CityOne Wynyard – Concept Plan

MP09_0076

Submission to the Department of Planning 03 March 2011

CITY OF SYDNEY 
city of villages

Figure 2. Concept Plan Drawing
'CityOne' Wynyard Project
Elevation to Carrington Street and section
to Wynyard Park by Hassall January 2011

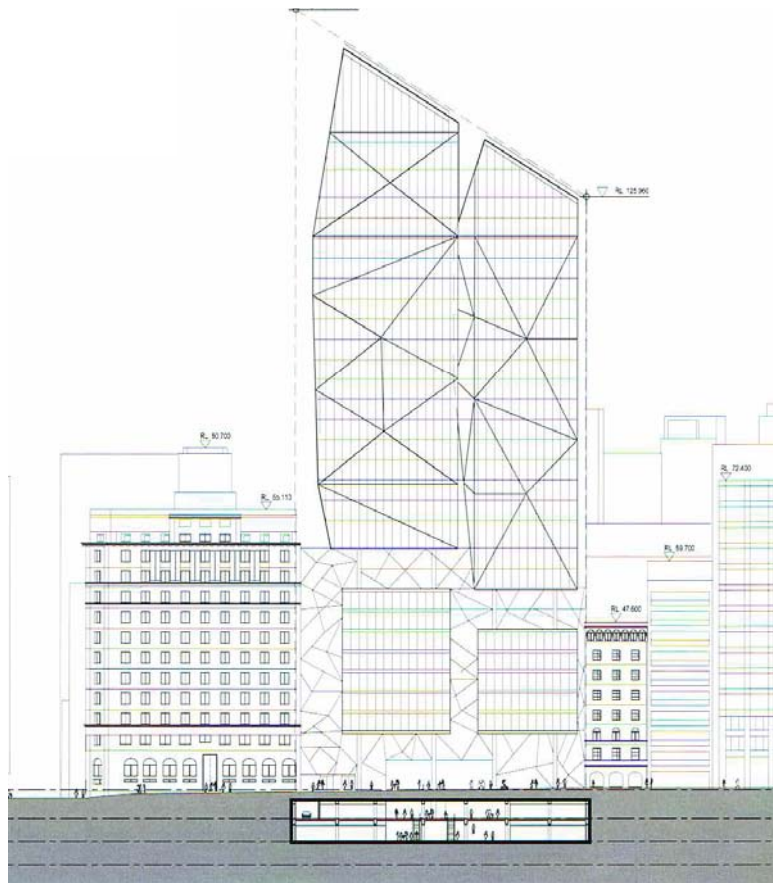
This however is entirely inappropriate. In the 2006 scheme, the extent of the non-setback tower width was less than half the width of the overall site (hence the reference in the commentary to ‘*given the relatively narrow frontages of the tower to the street*’), whereas the current 2011 concept plan has the extent of non-setback tower being the full width of the site in both Carrington and George Streets (see Figure 2).

Figure 3. Proposed aggregated 'site area' by JBA Urban Planning, EA, January 2011

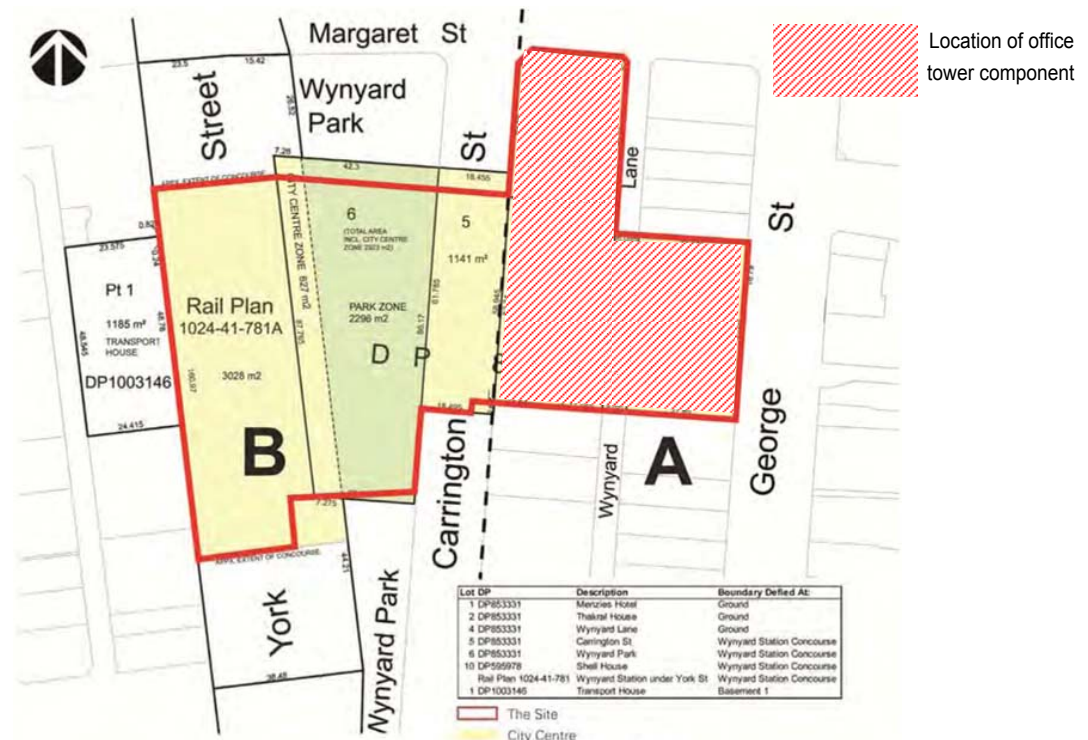
The 2011 Concept Plan seeks to include the sub-surface stratum above and under Wynyard Lane, and under Carrington Street and York Street as the 'site area'. The City of Sydney disagrees with this approach for three key reasons (there are others):

1. While this proposed area aggregation excludes Wynyard Park, and is limited to stratum owned by Railcorp above and generally below roadways, it is the City of Sydney's view that this is an improper calculation and is inconsistent with the Sydney LEP2005 Part 4 Clause 58 (2) site area definition for the purposes of calculating floor space ratio. This is stated without viewing a referenced opinion by Blake Dawson Waldron in the EA.
2. In addition to 1 above, the elimination of Wynyard Park makes the aggregation of lots in question discontinuous in relation to the large stratum under York Street.
3. Although the aggregated sub-surface site area of Wynyard railway station and its concourses has been successfully used to trigger the Minister for Planning as the consent

Figure 4. Plan. Upper foyer which should be removed so that transit hall can be properly realised and a high open space.

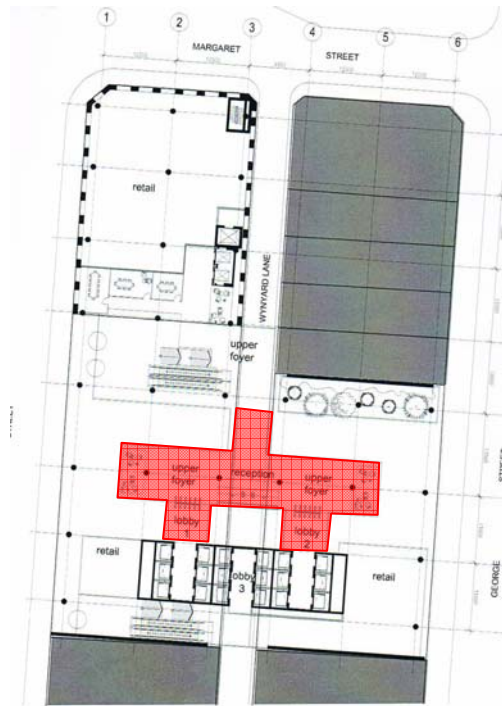
One of the few potential 'public benefits' located within the Thakral site is the proposed new station transit hall accessed from George Street through to Carrington Street (replacing the twin Wynyard ramps). Any approval of the Concept Plan should be conditional so that the transit hall be clear and unobstructed and the upper foyer to the commercial tower, which visually impedes this space, should be removed.

If the transit hall between George Street and Carrington Street is part of any Public Benefit schedule of works, the upper commercial foyer should be removed to ensure that the space lives up to the promise of a world class unobstructed transit volume.

Figure 6. Section. Circulation space at Wynyard Lane.

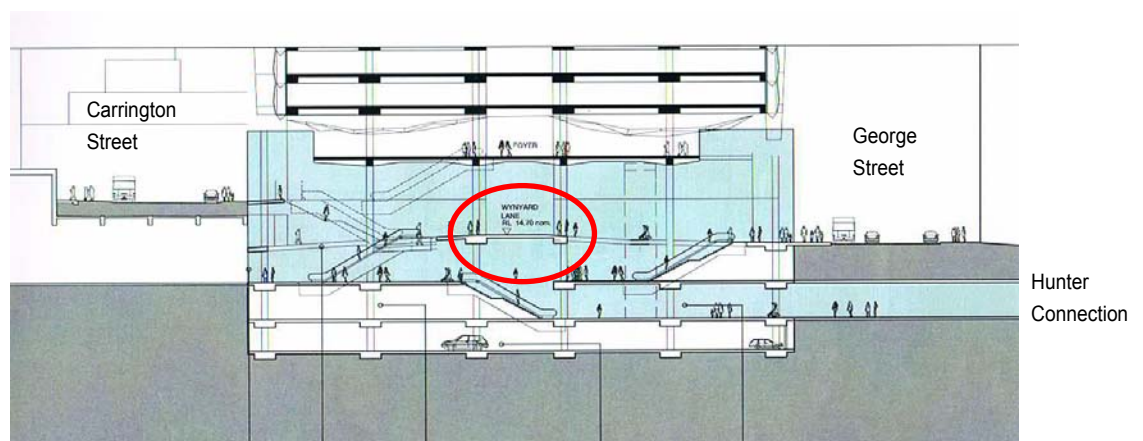
The proposed function and treatment of Wynyard Lane, involving vehicle access being provided across the new east-west pedestrian link is unacceptable (Figure 6). This critical issue in the Concept Plan must be resolved prior to any approval being issued, as any alternative solution has significant impact on adjoining properties and the portion of the lane owned by the City of Sydney.

The north-south Wynyard Lane link is just as important to the success of the Concept Plan as the east-west link from George Street to Carrington Street and the station access below. The City recognises the physical, topographical, access and ownership constraints presented by the laneway. The City also points out the opportunity to integrate a pedestrian laneway into the design, providing for activation, amenity improvements as well as an improvement to the legibility and permeability of Wynyard Station and surrounds. Wynyard Lane should be a pedestrian only link as it passes through the transit hall.

The Department of Planning convene a Working Party with the specific objective of addressing the issues associated with Wynyard Lane and its integration into the 'CityOne' Concept Plan. The Working Party should consist of members from the following groups:

Figure 9. 2006 Concept Scheme
(referred to in EA as justification
for no street wall)

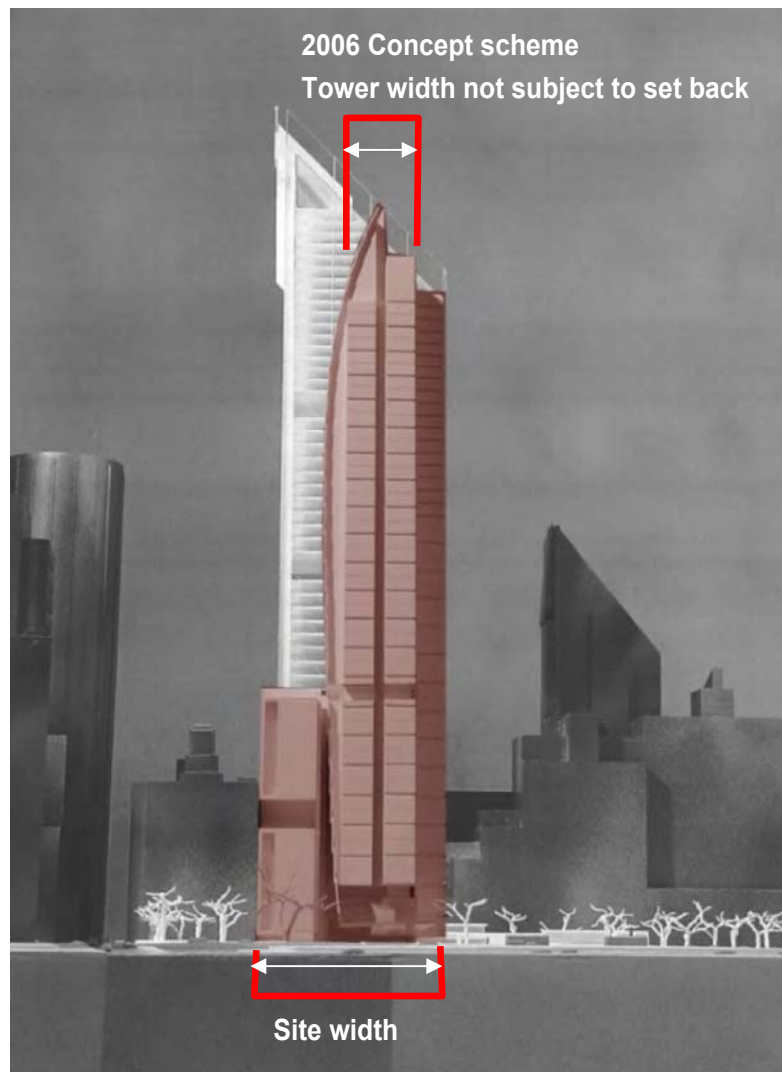
In relation to the key planning justification in the EA for the 2011 concept plan not respecting the important street wall height control and setback in Carrington Street, the EA refers to an earlier Architectus commentary on the 2006 scheme (Figure 9) as justification:

Reliance on this earlier commentary to justify a later scheme is inappropriate and is not relevant. With a full-width of site tower proposal, it is critical that a street frontage height to Carrington Street of approx RL 62 (to match the parapet of adjoining Shell House) be incorporated with an appropriate setback above (refer to Section 7). Only in the case of a significant and justified ‘contribution’ or public benefit, the City might consider an exception that while retention of the George Street setback is preferred it is not considered to be as crucial as Carrington Street.

Figure 11. Section.
Weighted average 8 metre setback k required to Carrington Street (absolute minimum of 6 metres), Zero setback to George Street

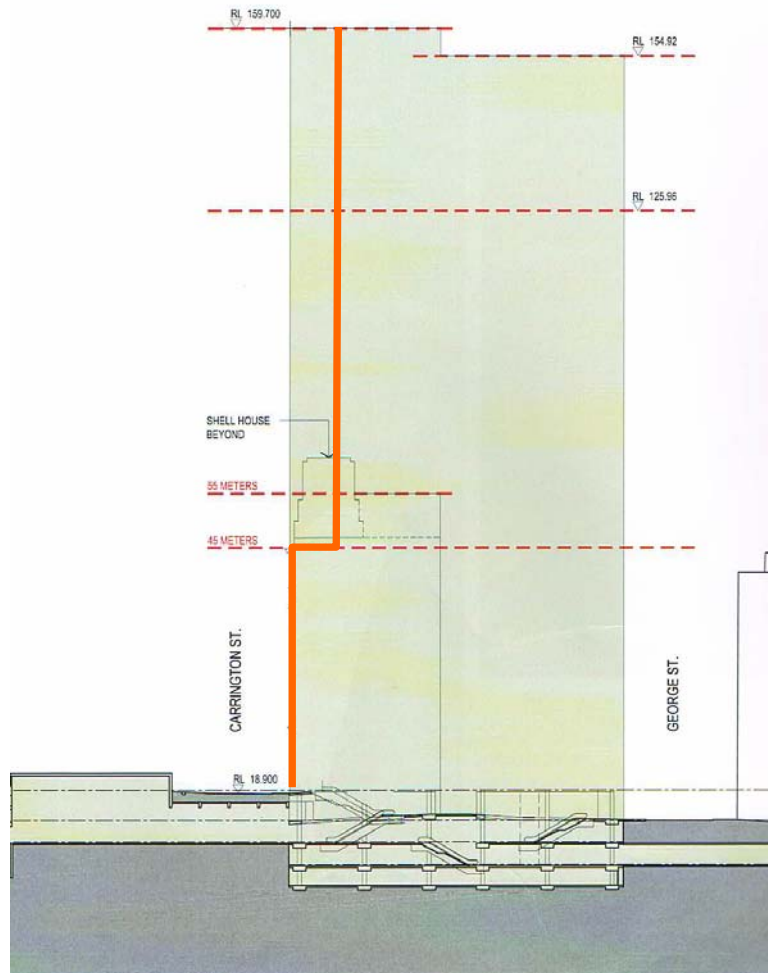
The environmental quality of Wynyard Park and the surrounding public domain (bus stops) is critical in assessing this project, and adequate testing of the proposed building envelope should be carried out to determine wind impacts. As a minimum, a weighted average of 8

metres (with an absolute minimum of 6 metres) is required for Carrington Street setback (instead of the site specific setback to Wynyard Lane as shown in the controls) but only in the case of a substantial and appropriate 'contribution' or public benefit (Figures 11 & 12).

That the proposal be required to maintain a setback to Carrington Street above RL 62 for a weighted average of 8 metres (with an absolute minimum of 6 metres).

Figure 20. Existing Shadow.
City preliminary shadow model of Wynyard Park.

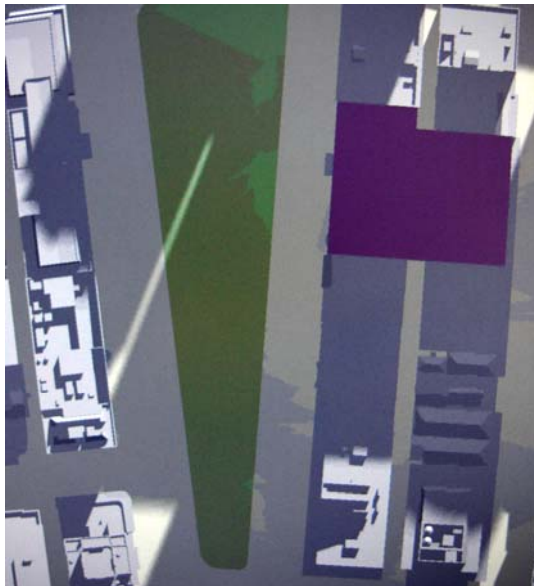
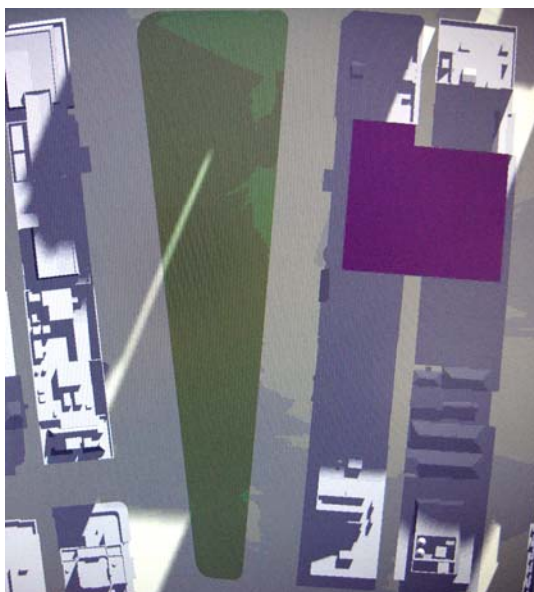
The question arises whether there is any additional overshadowing of Wynyard Park at all as a result of the proposal. Preliminary shadow analysis suggests that the proposed concept plan causes minimal additional overshadowing of Wynyard Park between the hours of 10.30am and 11.00am on the longest day of the year (June 21). Figures 20-12 show the shadow fall at 10.30am for the existing, proposed and preferred setback circumstances; Figures 23-25 show the shadow fall at 10.45am for the existing, proposed and preferred setback circumstances; and Figures 26-28 show the shadow fall for the existing, proposed and preferred setback circumstances at 11.00am. The third view in each scenario reflects the required tower setback above the street frontage height of RL 62 as described in Parts 6 and 7 of this submission. The setback has been calculated at 6 metres (absolute minimum) although the required setback is weighted average of 8 metres. By using the 6 metre line, it calculates for the worst possible condition at any point.

Figure 26. Existing Shadow.
City preliminary shadow model of Wynyard Park.

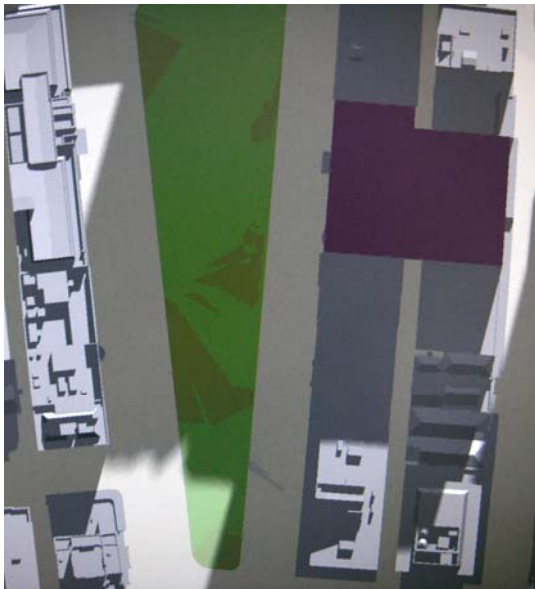
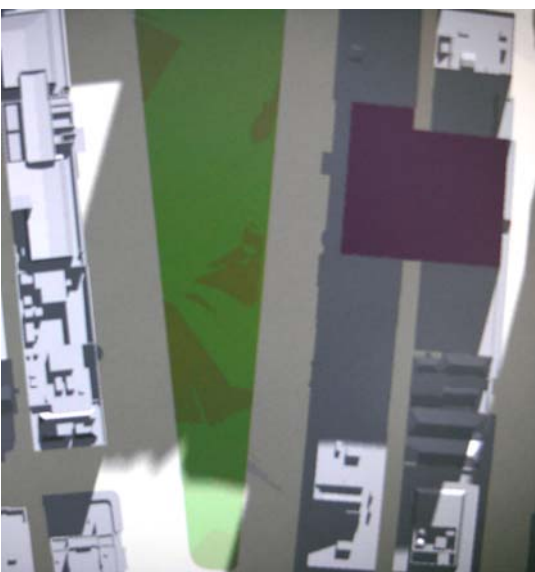
Given the scale of the proposal, the impact on Wynyard Park is minimal because the location of the impact at the ground plane is at the southern most end of the triangular park shape. At this location there is extensive asphalt paving and little vegetation (Figure 29). The canopy of the significant trees in Wynyard Park are much higher than the ground plane and will enjoy sun access in the morning.

The preferred scheme (with weighted average mean 8 metre setback) ensures that the southern end of the Park will have full sunlight by 11.00am in mid winter.
